APPLICATION FOR PERMIT
DEPARTMENT OF BUILDING INSPECTIONS SERVICES
ELECTRICAL INSTALLATIONS

LOCATION OF WORK: 12 Walker St.

Re: 12 Walker Street

Your application for a building permit to change the use of 12 Walker Street from 4 units to 3 units with alterations, as per plan, is being issued with the following requirements:

Plan of Bath and Stairs to Walker St.

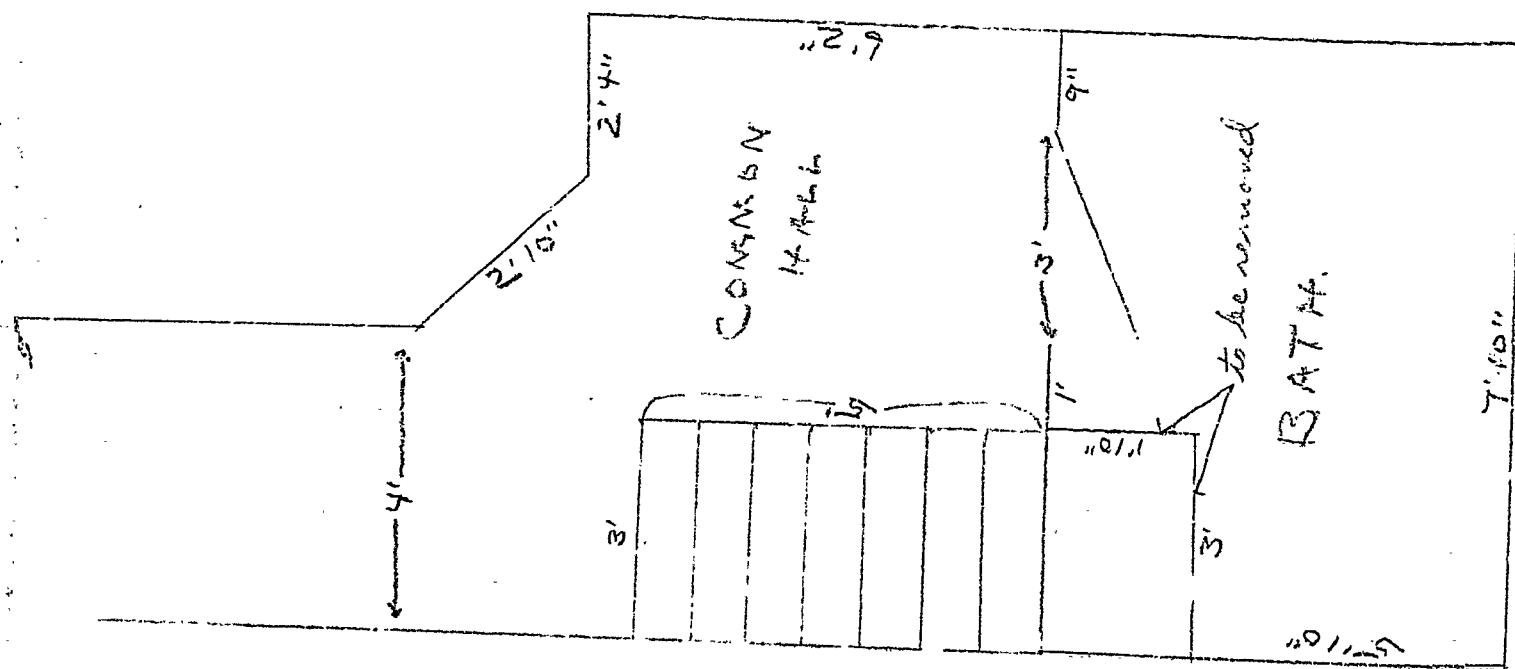
To remodel with 2. change with stairs
which do not lead to an exit.
Return to main room.

The owner, Mr. Maxim, indicates that stairway to be closed up is not a required means of egress and says that someone from your department has looked the situation over. Permit herewith is sent to you for approval if everything is satisfactory to your department.

EXISTING - Floor-PLAN - 22.32

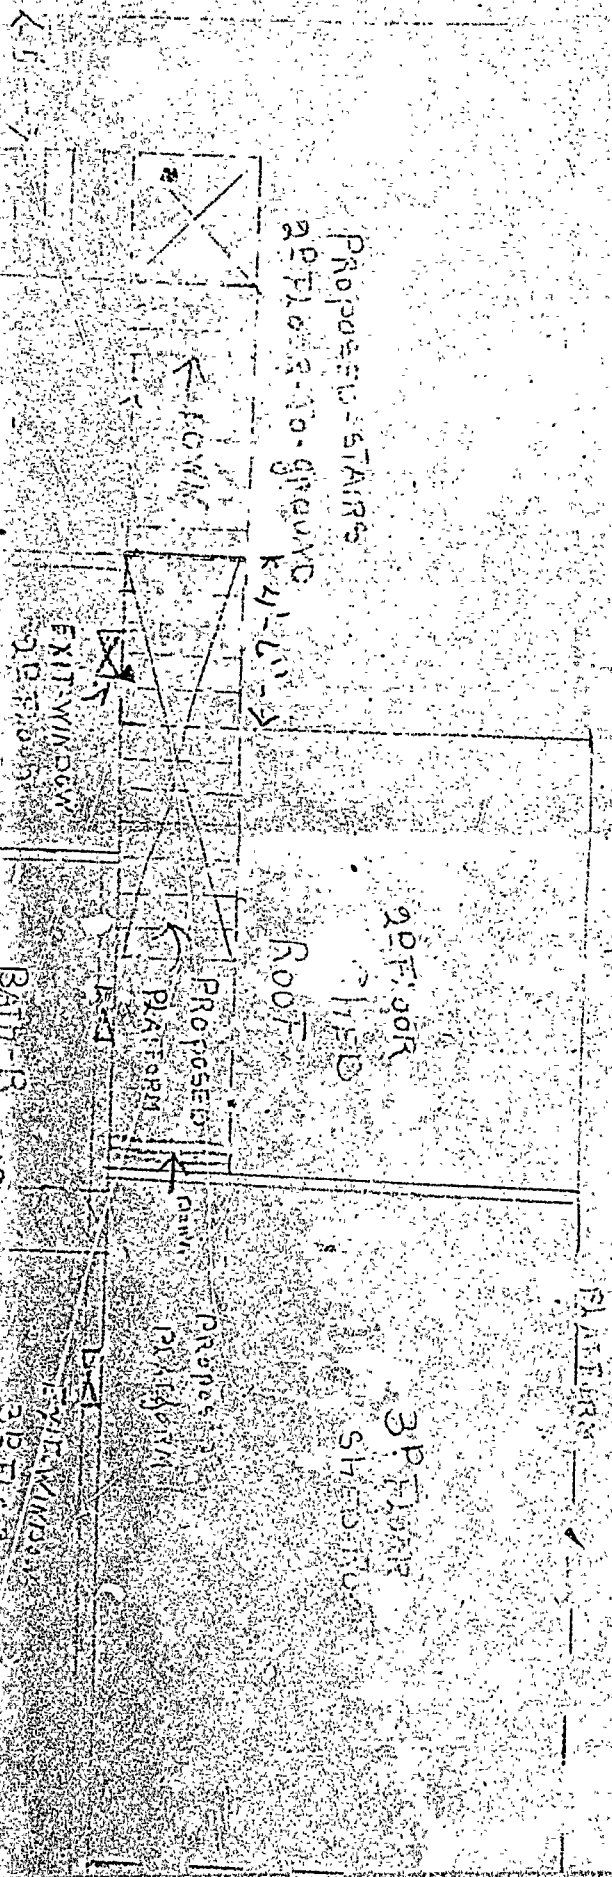
Apparently the present situation is dangerous from the standpoint of the safety of the occupants of the building, and for that reason I dislike to withhold the permit for the construction of the new stairway--although the plan of the stairway is lacking of some information to show compliance with Building Code requirements therefor.

The owner and her agent must of course bear responsibility due to loss of life on account of this dangerous situation. If the owner's agent desires me to issue the permit despite the fact the he now has full knowledge that the situation would not meet the requirements even after the fire escape were erected, I will do so upon notice from him--the permit to be issued with a letter which would clear up questions of compliance with the Building Code as to strength, arrangement etc. of stairway and means of reaching it.
